Peyton Estates Unit Six

City of El Paso — City Plan Commission — 10/4/2018

SUSU18-00080 — Major Final

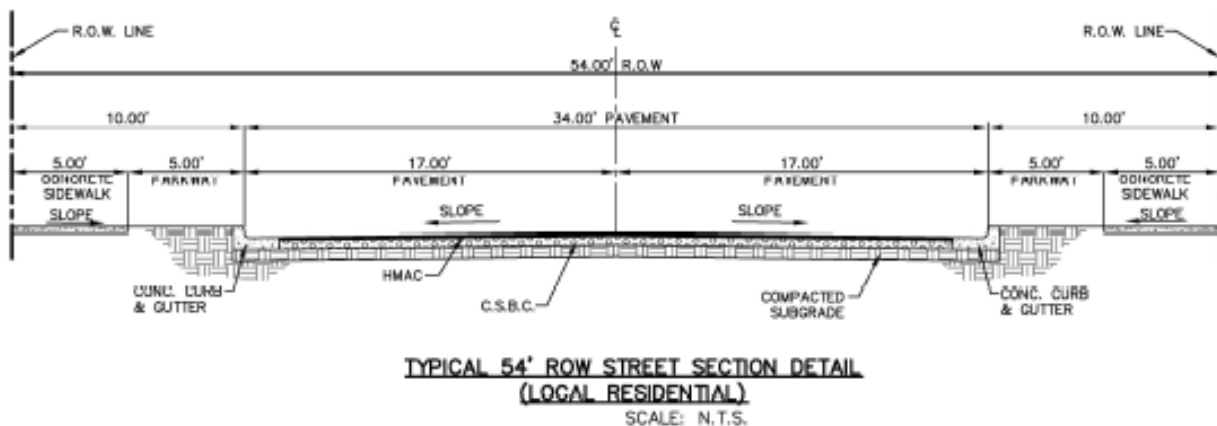
2. To allow a 54' ROW with 34' of pavement, a 5' landscape parkway and a 5' sidewalk. The applicant is proposing to decrease the pavement by 2' and increase the landscape parkway and sidewalk from 4' to 5', which exceeds the minimum DSC standards.

**TYPICAL 68' ROW STREET SECTION DETAIL
(LOCAL RESIDENTIAL)**

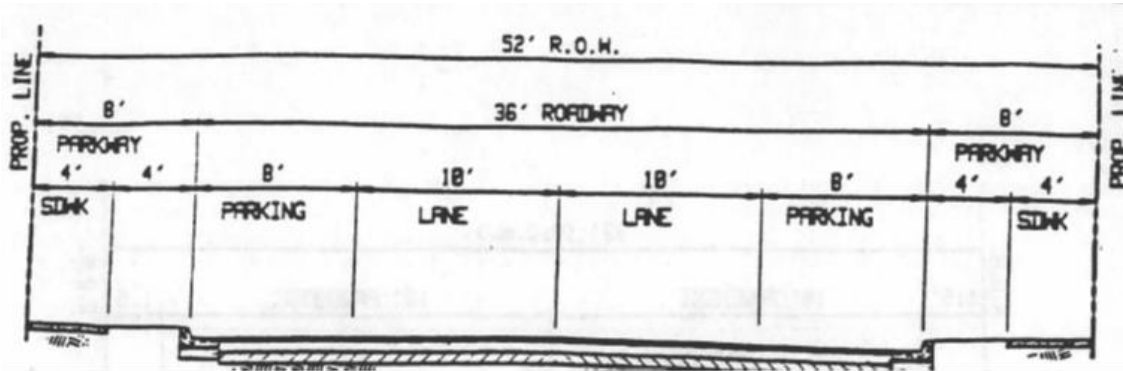
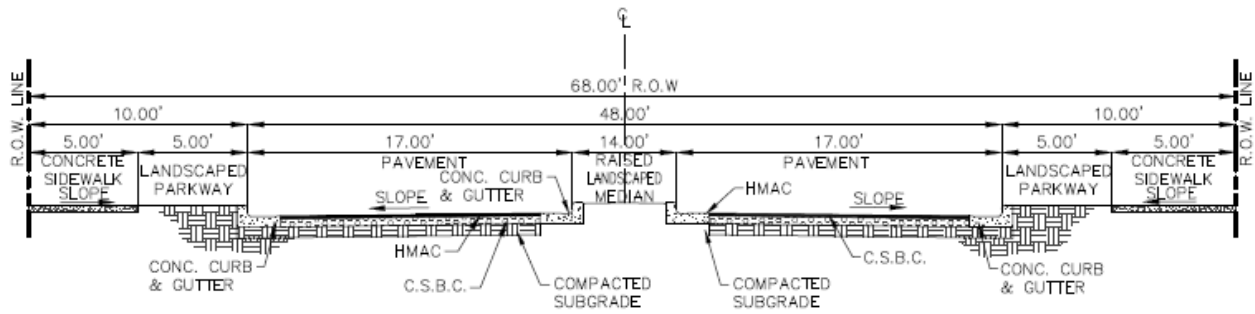
- To allow a 68' ROW with 34' of pavement, with a 14' raised landscaped median, a 5' landscape parkway and a 5' sidewalk, which exceeds the minimum DSC standards.

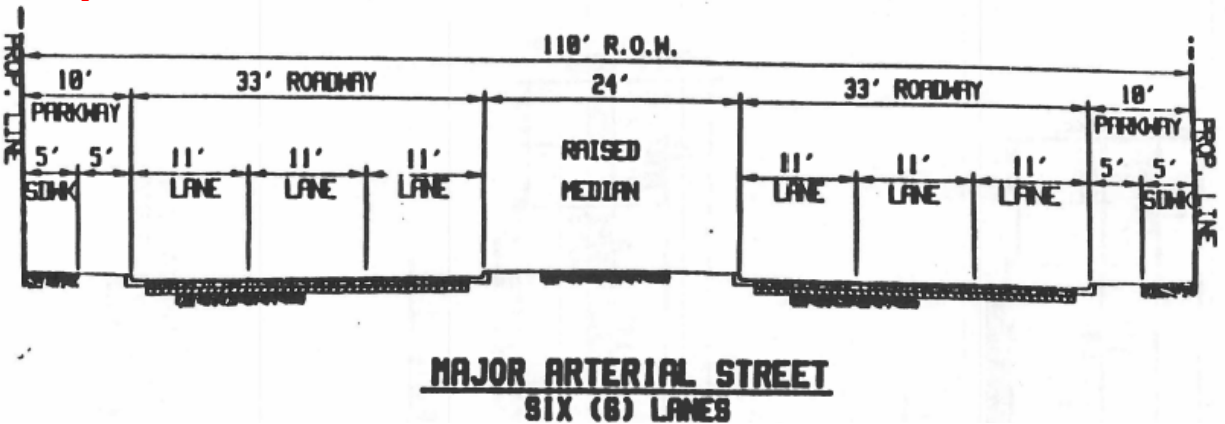
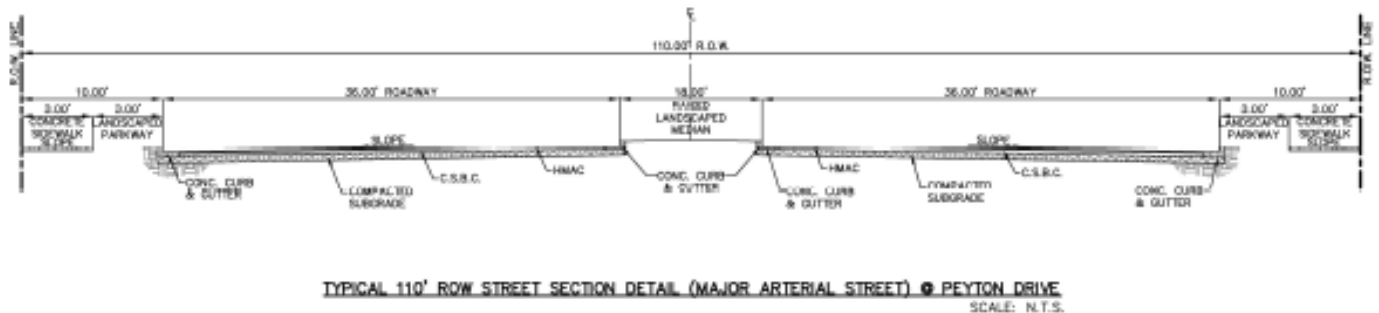
4. To allow a 110' ROW with 72' of pavement, an 18' raised landscaped median, a 5' landscape parkway and a 5' sidewalk. The applicant is proposing to decrease the median width by 6' and increase the pavement width by 6'.

ATTACHMENT 2

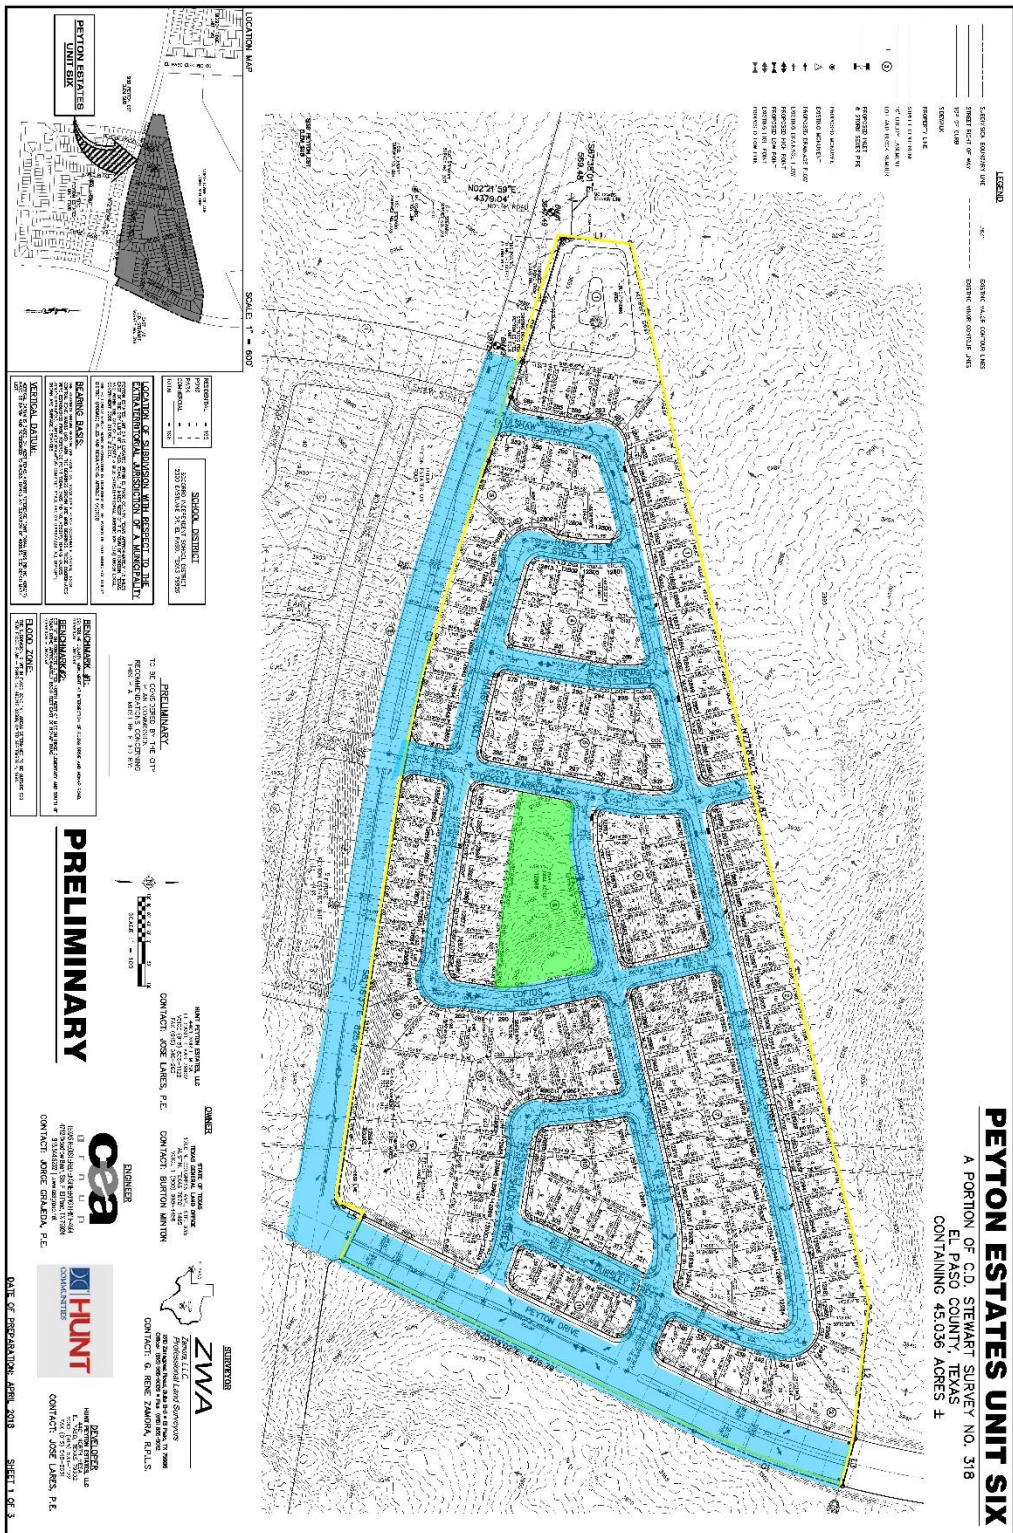
1. Provide a note specifying Lot 33 Block 9 is to retain it's own runoff.
2. Increase visibility of runoff arrows on map of topography and runoff on Engineering report sheet.

1. The park was relocated from Block 6 to Block 8, which appears to have yielded an additional 4 lots. - Does not appear to be an issue with County requirements.
2. The 68' ROW (17' pavement with 14' raised median) was previously approved by the County as a 76' ROW (22' pavement with 12' raised median). - This would require to be reviewed and approved by the ESD Fire Marshal and then approved by the commissioners court for a revised variance request.

The District has a request to flip the addressing on Shildon St so addressing increases in the same direction as the other streets going west to east. The District also request that Newquay St and Loftus St have just one address range, preferably 200s seeing as the school south of Rojas Dr is at 150. We have had comments from the public and emergency responders having issues with unexpected address range breaks on a street with no physical breaks in the street. We also recommend that even addressing on Clevedon St begin at 12900 to end at 12960, these addresses conform better to the addressing schema on this street. We also recommend even addressing on Haxby St begin at 12808 through 12888.
